UNITED STATES PATENT AND TRADEMARK OFFICE

Office Action Summary

10/518,161

DETAILED ACTION

Fig. 2A

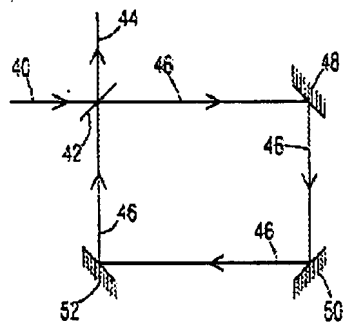
Regarding claim 1, Jutamulia (Fig 2A, for instance) discloses a method of manipulating an optical signal comprising the steps of splitting the optical signal 40 into a first signal 46 and a second signal 44, using the second signal as a signal undelayed with respect to the optical signal, delaying the first signal with respect to the second signal by sending the second signal on a path comprising mirrors 48, 50, and 52, splitting the first signal in to a first part that is reflected by splitter 42 and a second part that is transmitted through splitter 42, using the second part of the first signal as a delayed signal that is interferometrically combined with undelayed beam 44, and repeating the steps with the first part of the first signal (see Col. 5, lines 1-7 for instance).

As for claim 2, the second signal 44 travels on a path away from the delay loop that first signal 46 travels.

As for claim 3, splitter 42 can divide the energy of the input beam 40 into beams 44 and 46 in any ratio, but for simplicity divides the energy of input beam 40 equally between beams 44 and 46 (Col. 4, lines 46-50).

As for claim 4, see splitter 42.

Regarding claims 7 and 8, Jutamulia (Fig. 2A, for instance) discloses an apparatus for manipulating an optical signal comprising a first splitting device 42 for splitting the optical

signal into a first signal 46 and a second signal 44, a delaying device comprising a loop formed by mirrors 48, 50, and 52 that delays the first signal with respect to the second signal so that the second signal can be used as a signal undelayed with respect to the optical signal, a second splitting device which is the same as the first splitting device 42 (as per claim 8) that splits the first signal into a first part that is reflected by the splitter and a second part that is transmitted through the splitter, so that the second part of the first signal is a delayed signal that is interferometrically combined with undelayed beam 44, and a repeating device in the form of the mirror loop 48, 50, 52 that provides the first part of the first signal to the splitting device.

As for claim 9, the splitter 42 is a beam splitter.

As for claims 10 and 11, mirrors 48, 50, and 52 comprise a loop that delays the beam and acts as a repeating device to continually delay the beam.

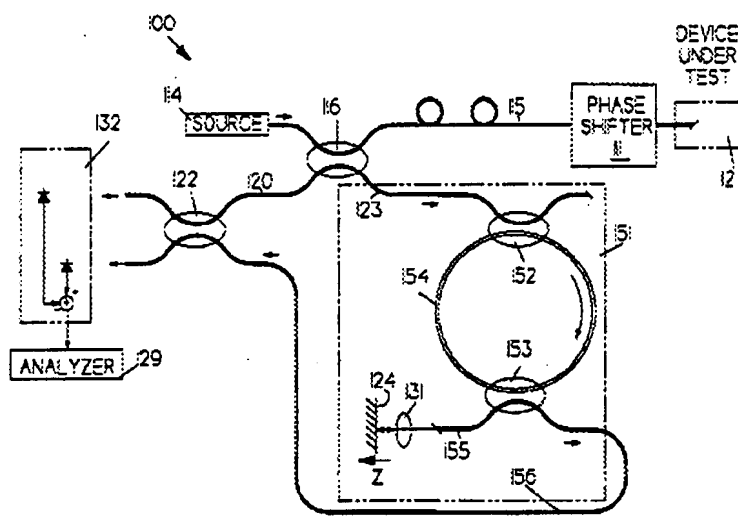
As for claim 5, Baney (Fig. 2) discloses a method comprising splitting an initial light beam from source 114 using coupler 116 into a measurement beam down path 115 and a reference beam down path 123, coupling the measurement beam into the optical device under test 12, letting the reference beam travel a different path as the measurement beam, superimposing the reference beam and the measurement beam at coupler 122 to produce interference, detecting the power of the resulting superimposed light beam at detector 132 as a

function of the frequency when tuning the frequency of the light beam using phase shifter 111 (see Col. 3, lines 32-52 which describes the function of phase shifter 11 in Fig. 1 which is identical to the phase shifter 111 in Fig. 2), and deriving optical properties of the device under test with analyzer 129.

As for claim 12, Baney (Fig. 2) discloses an apparatus comprising a first beam splitter 116 for splitting an initial light beam from light source 114 into a measurement beam down path 115 and a reference beam down path 123 of an interferometer 100, a connecting device 115 for coupling the measurement beam into the optical device under test 12, an apparatus 151 for manipulating an optical signal that lets the reference beam travel a different path as the measurement beam (also fiber 123), a second beam splitter 122 for superimposing the reference beam and the measurement beam to produce interference in a resulting superimposed light beam, a detector 132 for detecting the power of the resulting superimposed light beam as a function of the frequency when tuning the frequency of the light beam using phase shifter 111 (see Col. 3,

lines 32-52 which describes the function of phase shifter 11 in Fig. 1 which is identical to the phase shifter 111 in Fig. 2), and a processing unit 123 for deriving optical properties of the device under test.
